CARRIER, MAINTENANCE, FULL TRACKED, FV434 MKS 1 AND 1/1

MODIFICATION INSTRUCTIONS AND INDEX

MODIFICATION INSTRUCTION NO. 1

SUBJECT: EMER TV E 107/4 Modification Instructions No. 1 to No. 27

a. See Fig 1

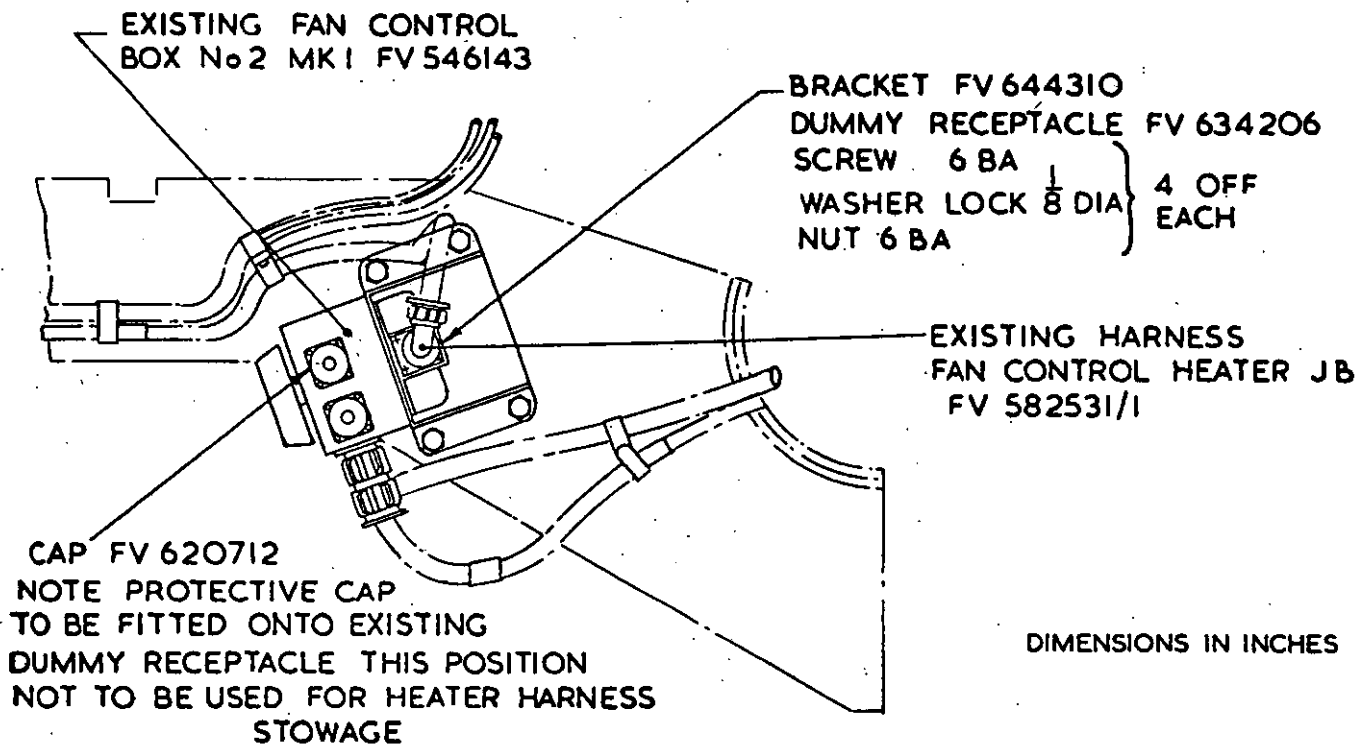
- (1) Attach dummy receptacle (FV 634206) to bracket (FV 644310), using the four No 6 BA screws, nuts and 1/8 in. lock washers provided as shown.
- (2) Fit the bracket assembly to right of fan controller on cross bulk-head, using existing fixing items.
- (3) Fit protective cap (FV 620712) provided to existing dummy receptacle as shown.
- (4) Fit existing heater harness (fan controller - heating JB, FV 582531) to new dummy receptacle fitted as shown.

Fig 1 - Assembly Detail

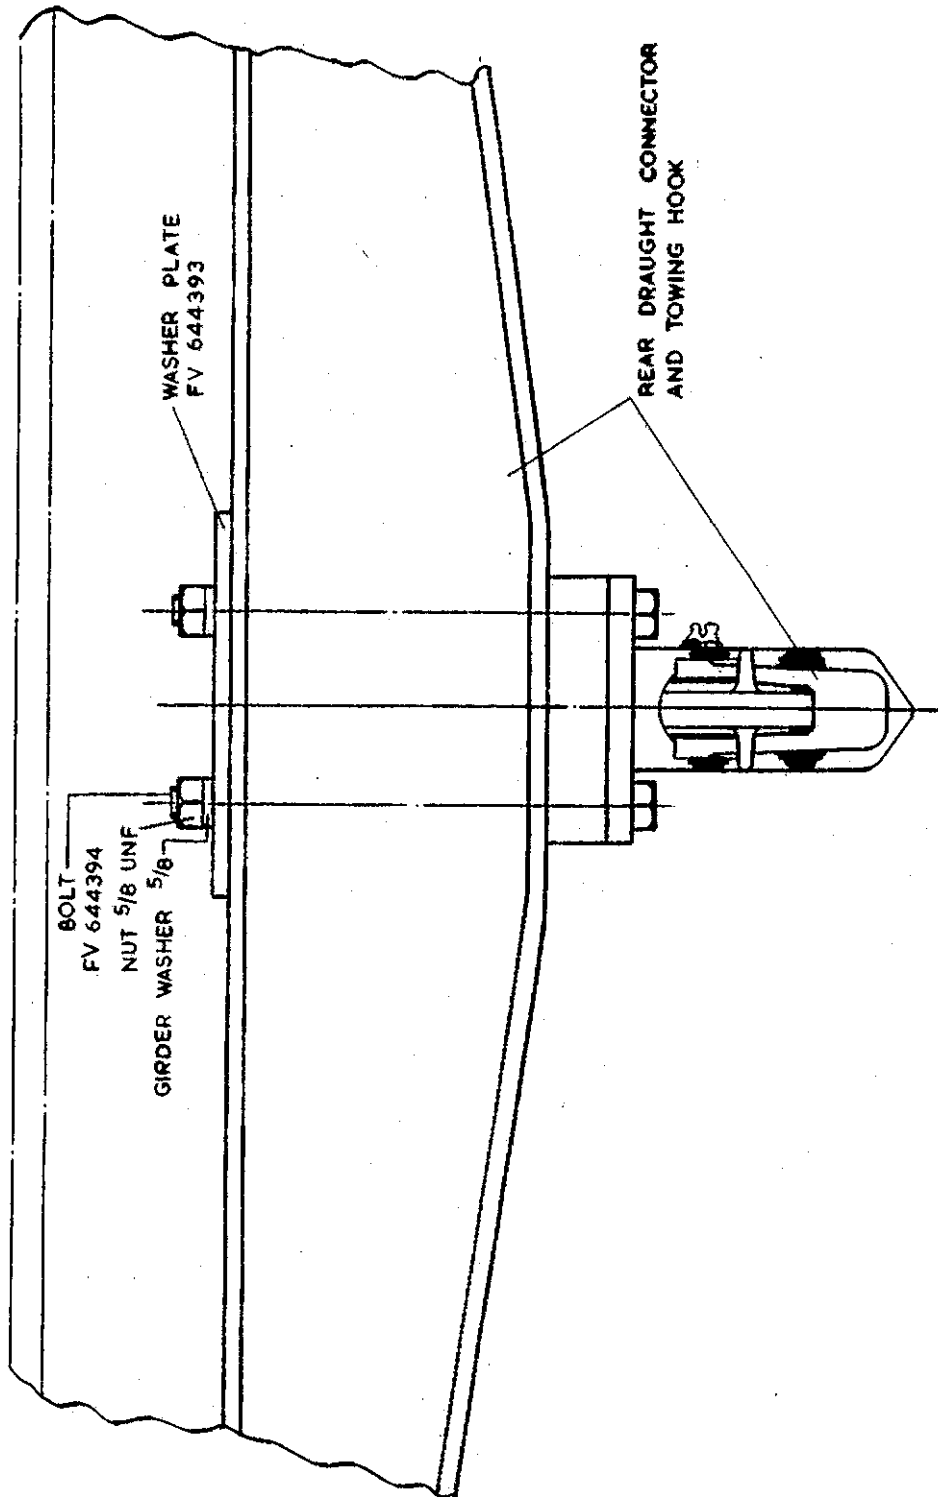
To give added strength and prevent the securing bolts from being "pulled through" a mild steel backing plate is to be fitted.

a. Remove the existing 5/8 in. UNF nuts and girder washers from the bolts which secure the towing hook to the rear draught connector.

b. Replace each existing bolt in turn with a bolt from the mod-set. Fit backing plate (FV 644393) and secure with the new girder washers and nuts provided.

Fig 3 Orientation of Flow Control Valves

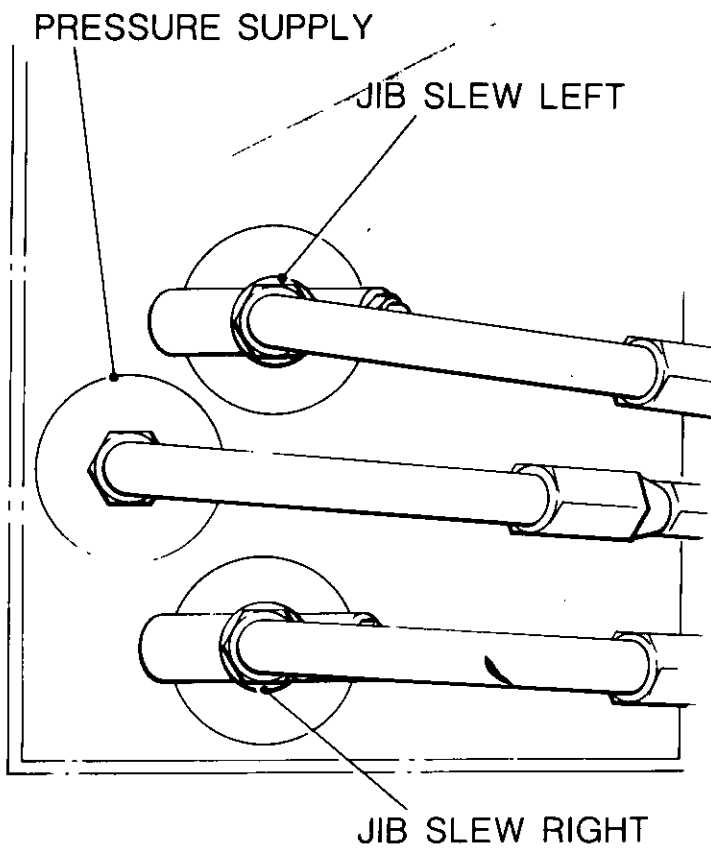
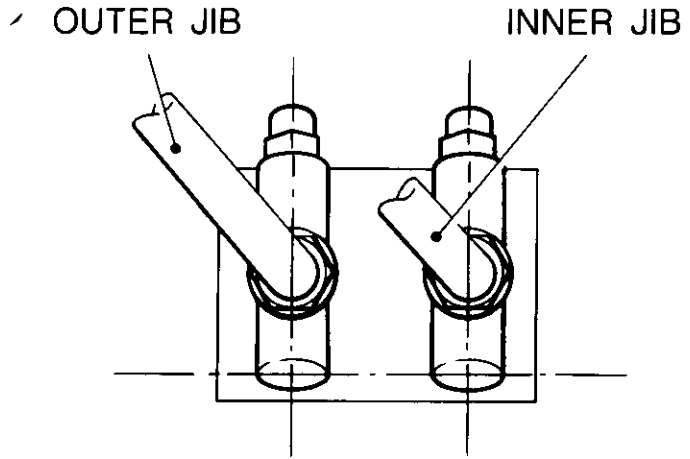
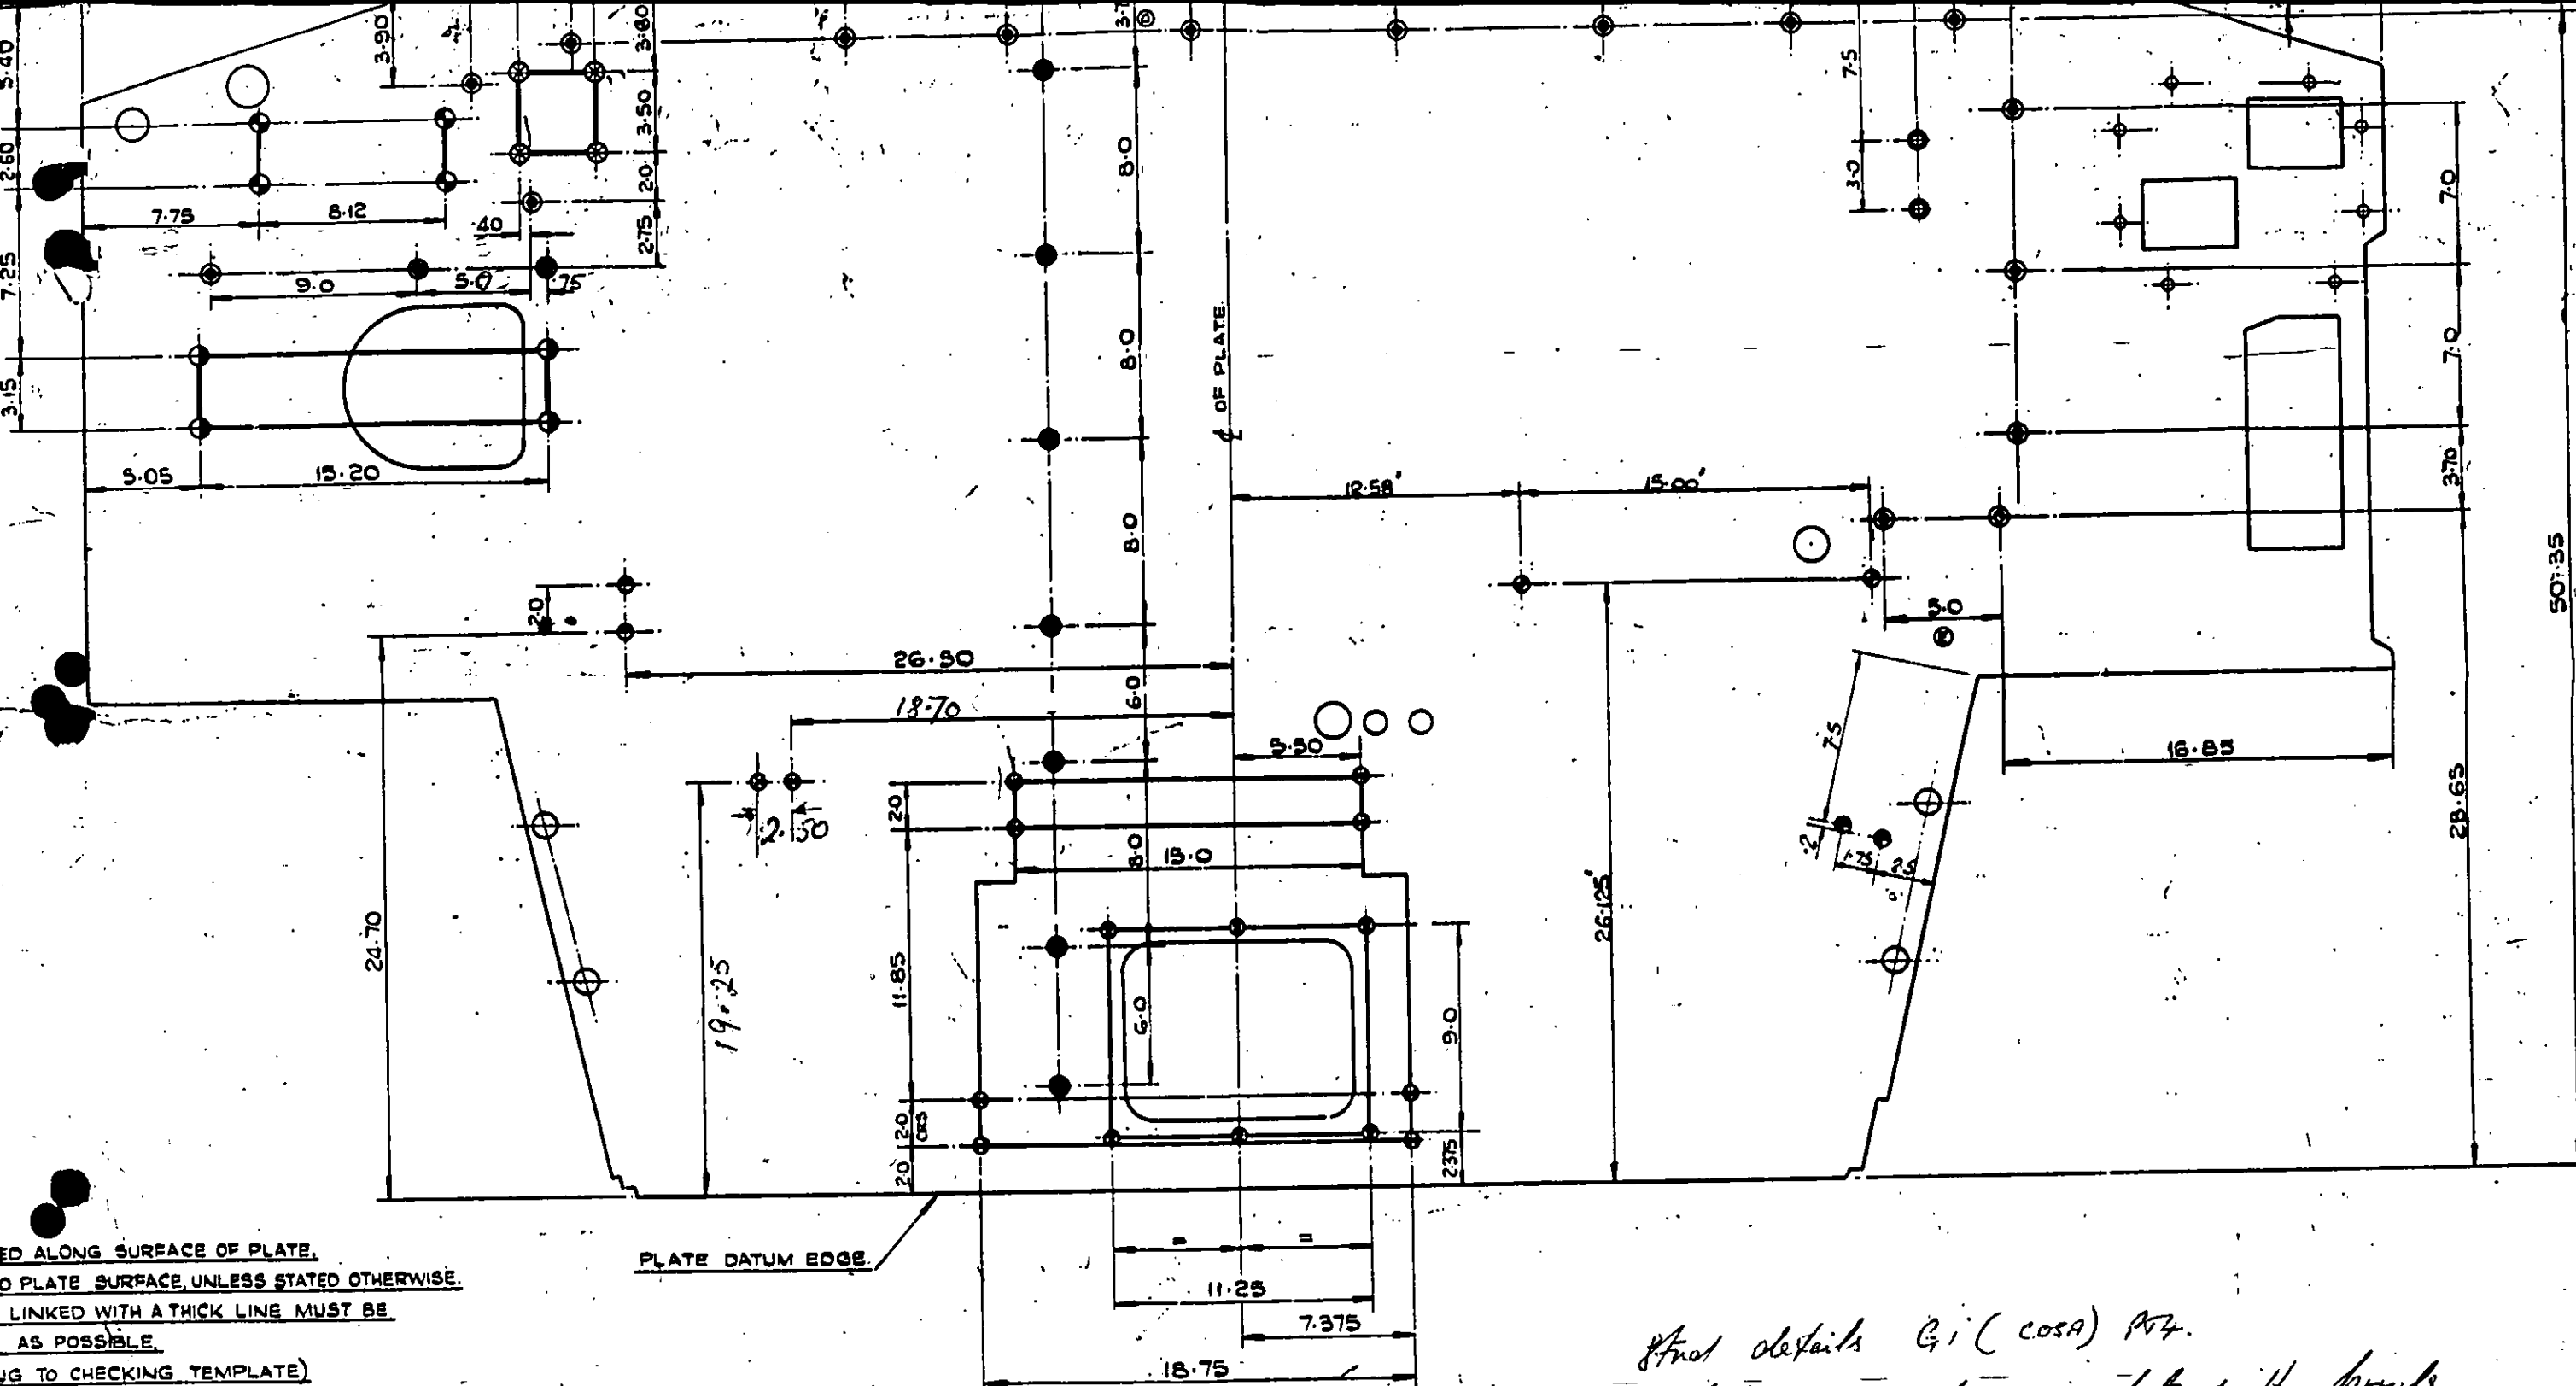
Ensure when fitting control valves that the free flow arrows on the valve body are pointing in the correct direction.

Crane Slew: Towards the vehicle port connection (away from hose connection) Figure 1.

Inner and Outer Jib: Away from the vehicle connection (towards the hose connection) Figure 2.

9.2 Fit seals (2) to adaptors (3 and 4), screw adaptors into flow control valves (1) and tighten to 30.5 Nm (22.5 lb ft). Ensure flow direction is correct (see Caution).

Fig 1 Fire extinguisher mounting front

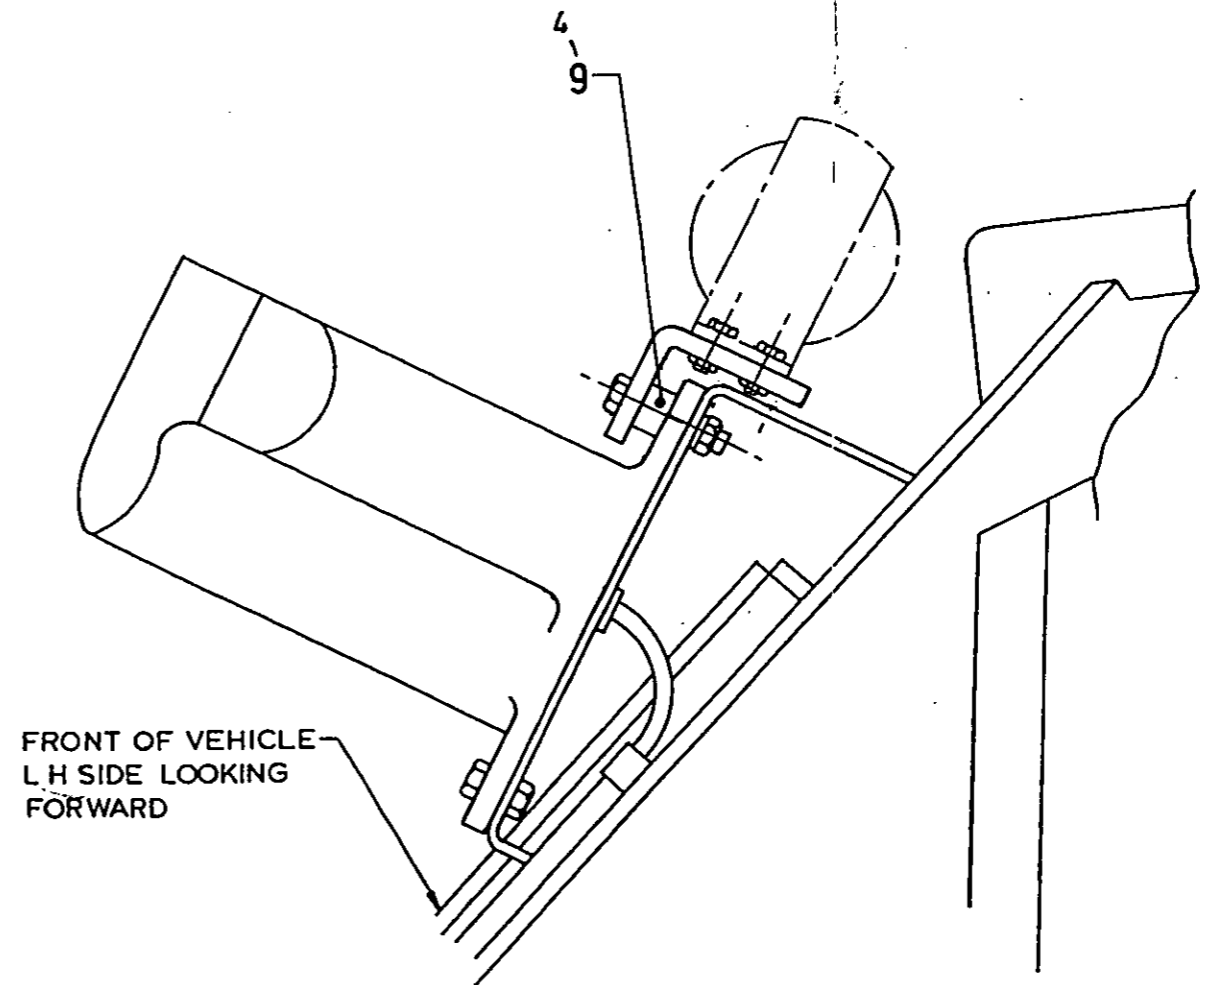
- 9.3 Remove bolts, nuts and washers (items 10, 11 and 12) from smoke discharger (Fig 1). Attach mounting plates (items 1 and 2) and spacers (item 9) to smoke discharger brackets using screws, washers and nuts (items 4, 6 and 8).
- 9.4 Refer to Fig 2 remove three welded studs (2BA x 7/16 lg) from rear plate, finish smooth and flush to plate.
- 9.5 Mark out and drill six holes (0.281 in. dia) through rear plate (Fig 2) for hole positions.
- 9.6 Repair paint, finish to DTD 5555 and Def Stan 03-32.
- 9.7 Attach fire extinguishers bracket to the rear plate using screws, washers and nuts (items 3, 5 and 7).
- 9.8 Clip on fire extinguishers Qty 3.
